**From:** [REDACTED]  
**Sent:** 27 January 2026 22:24  
**To:** Ann Biggs  
**Cc:** [REDACTED]  
**Subject:** URGENT - Absence of Lighting Assessment, Headlight Glare, Gradient & Operational Amenity DM/25/2626 - 42 Hurst Road, Hassocks

**Subject:** RE: DM/25/2626 - 42 Hurst Road, Hassocks

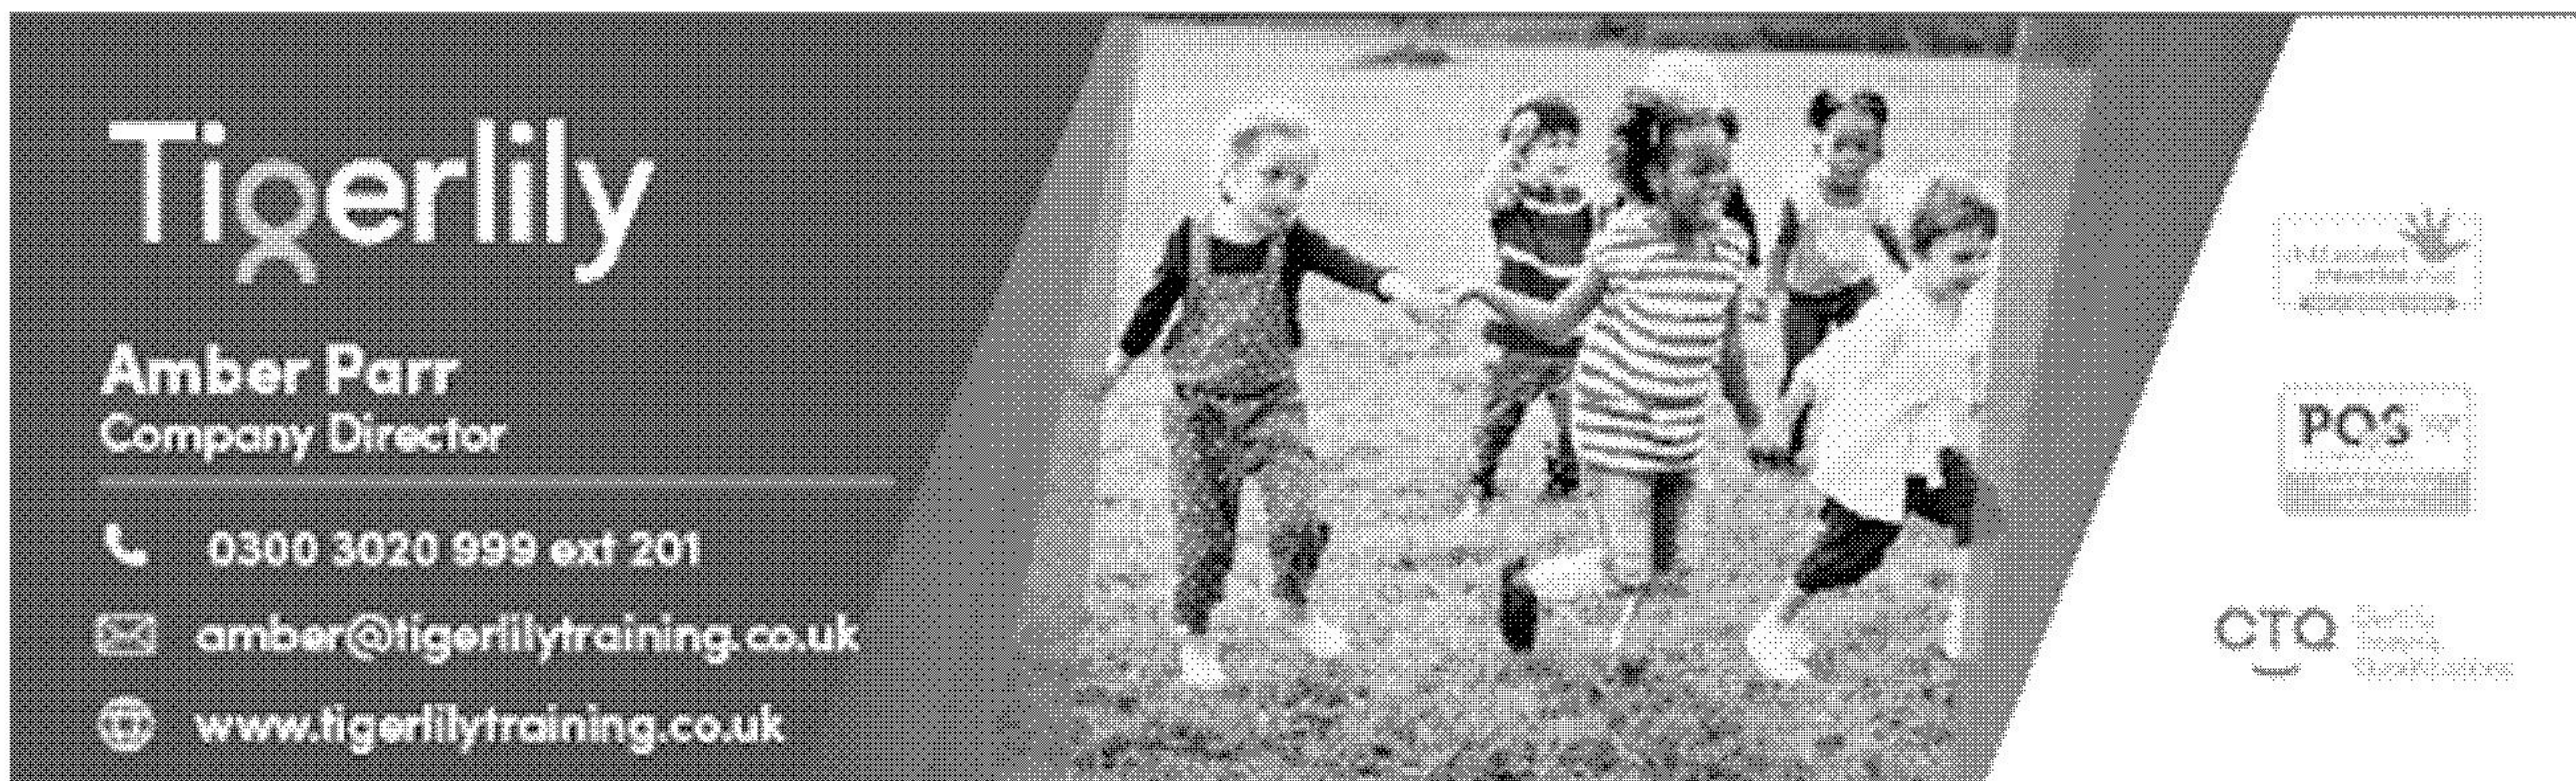
I am so sorry for the number of emails. The report by Arbrosense does not solve the issue for the following reasons:

- The **Root Protection Area radius**
- The **percentage of RPA affected**
- Whether the driveway sits **within the structural roots zone**

- Ash trees are **particularly sensitive to compaction. And the Ash tree is very valuable as in excellent condition**
- Repeated **car turning, braking, idling** causes:
  - micro-compaction over time
  - oxygen deprivation
  - gradual root dieback (not immediate, but progressive)

- Cellular system depth
- Load class (cars vs vans vs delivery vehicles)

- Geotextile layering
- Installation method (hand-laid vs machinery)

The only way to protect this tree which is integral to our protection and outdoor environment is to move the proposed driveway away from our boundary.

I have attached photos of how close the tree and our living area is to the proposed road. Due the gradient the structural roots are under the proposed site and for all the reasons above this tree will be become a danger to life if its roots are affected.
